Calvert Cliffs Nuclear Power Plant, Unit Nos. 1 and 2
Renewed Facility Operating License Nos. DPR-53 and DPR-69
NRC Docket Nos. 50-317 and 50-318

Subject: Request for Additional Information Regarding the National Fire Protection Association Standard 805 License Amendment Request

**REQUEST FOR ADDITIONAL INFORMATION REGARDING THE
NATIONAL FIRE PROTECTION ASSOCIATION STANDARD 805**

Figure 4-8 – NFPA 805 Monitoring Program Flowchart (Part 1 of 2)

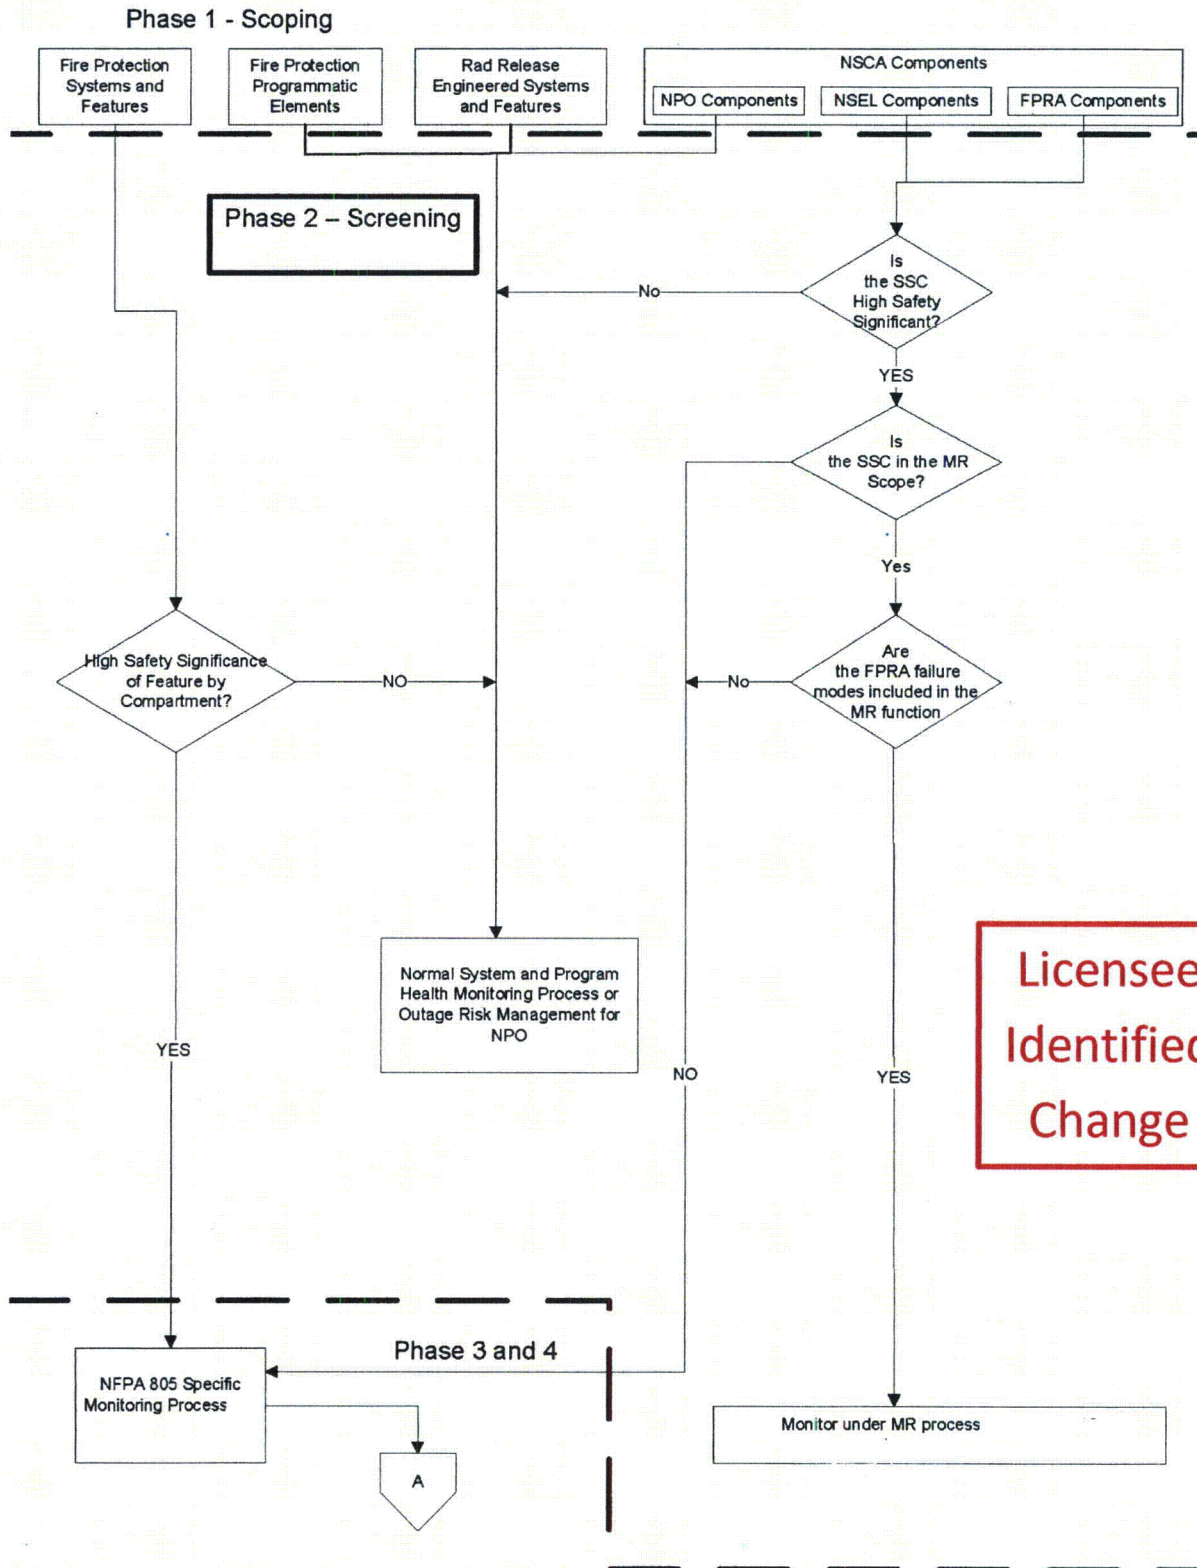
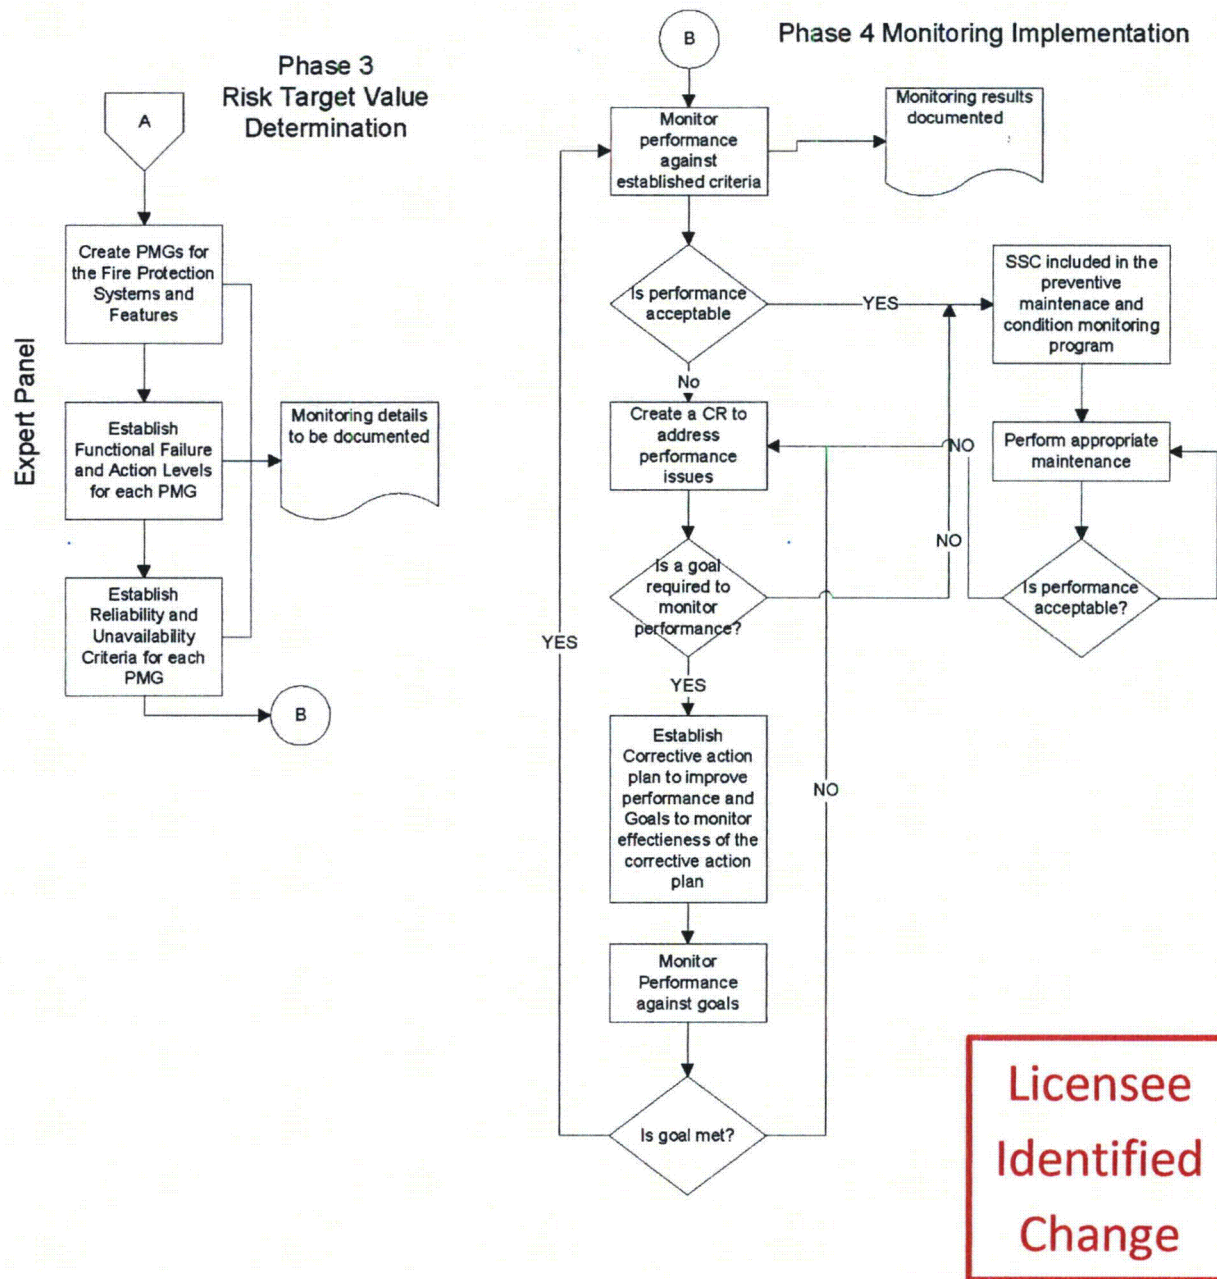
Another licensee identified change is described in updated pages 46 and 47. These changes update the flowchart. We request that these changes be included in the application review.
